July 21, 2010

Re: Lot 9, Blk 4 Four Hills Village 14th Installment Grading and Drainage Plan
Engineer's Stamp date 7-13-10 (M23/D009)

**LOT 9, BLOCK 4, FOUR HILLS VILLAGE
14th INSTALLMENT**

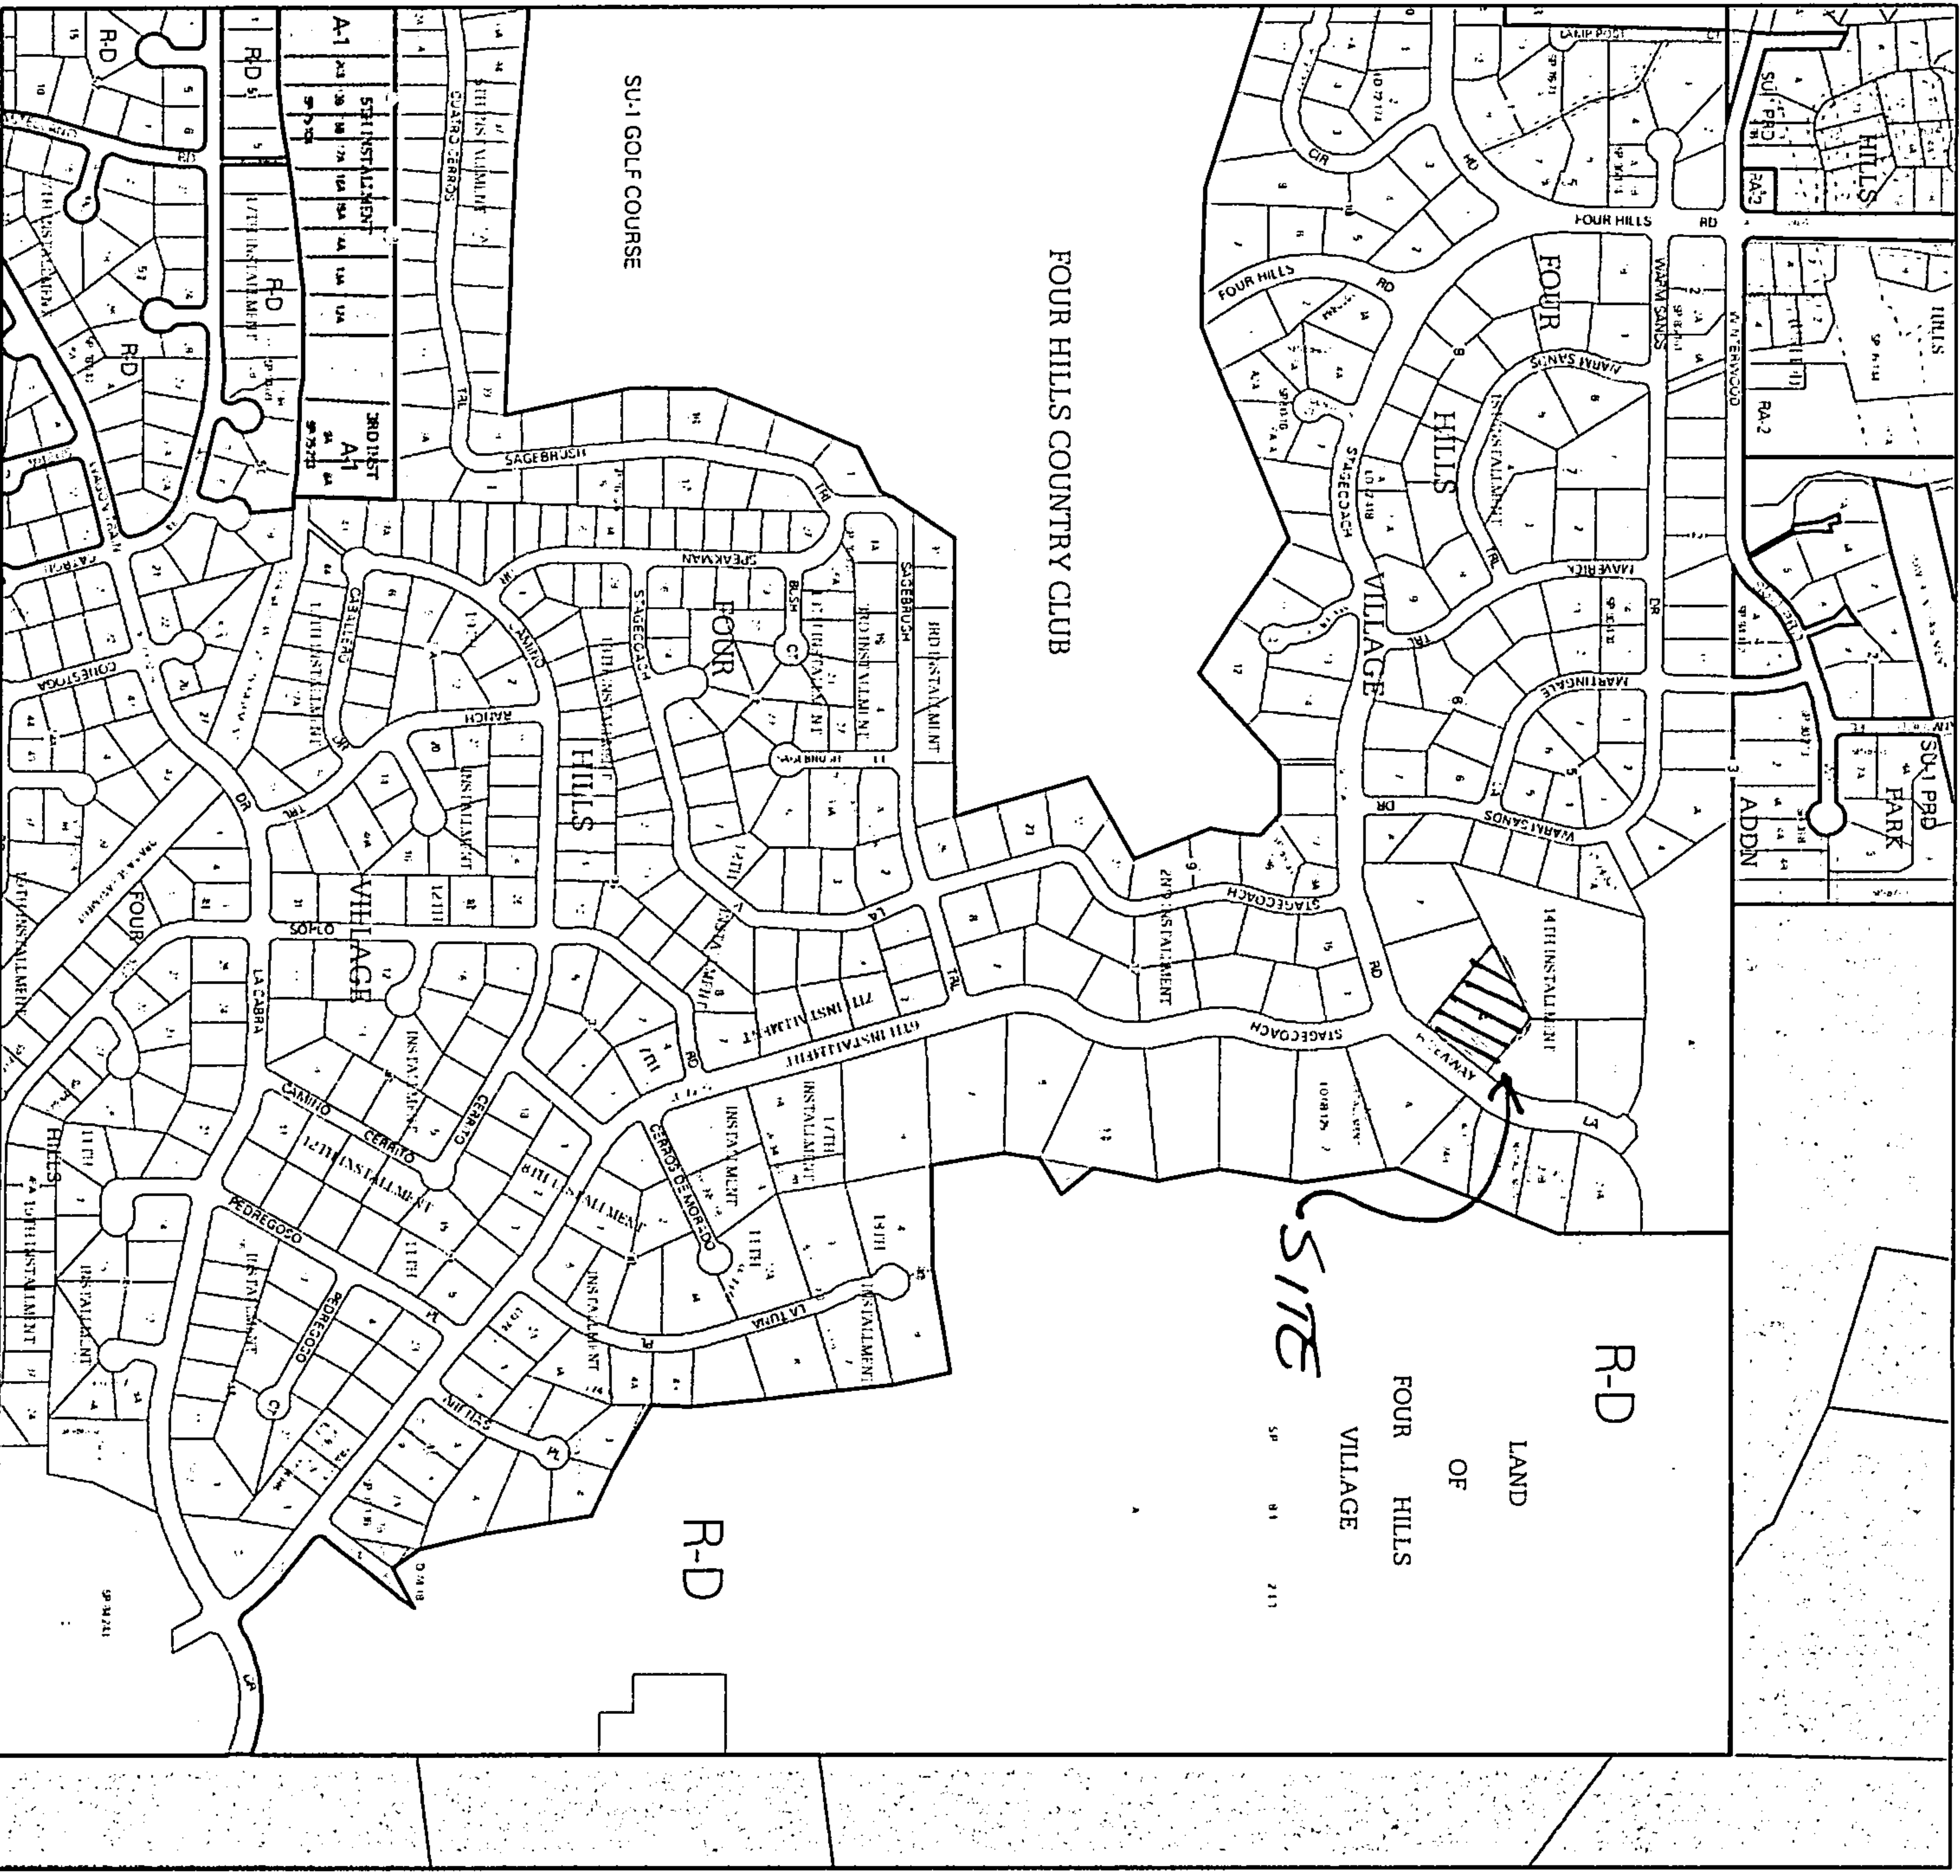
I spoke with the owner concerning development of these lots. He was concerned of the comment "Roof flows on the southern lot should drain down the driveway."

His concern was that he may not pave the driveway.

The plan is not approved for Grading Permit. A Grading and Drainage Plan for Building Permit will be required for each lot. Roof flows on the southern lot should drain down the driveway to Hideaway Lane. Erosion control will be required on both lots.

I told him the intent was to not have concentrated roof flows exit the property to the south.

So, if he can do something else as long as there are no concentrated roof flows leaving the property to the south.
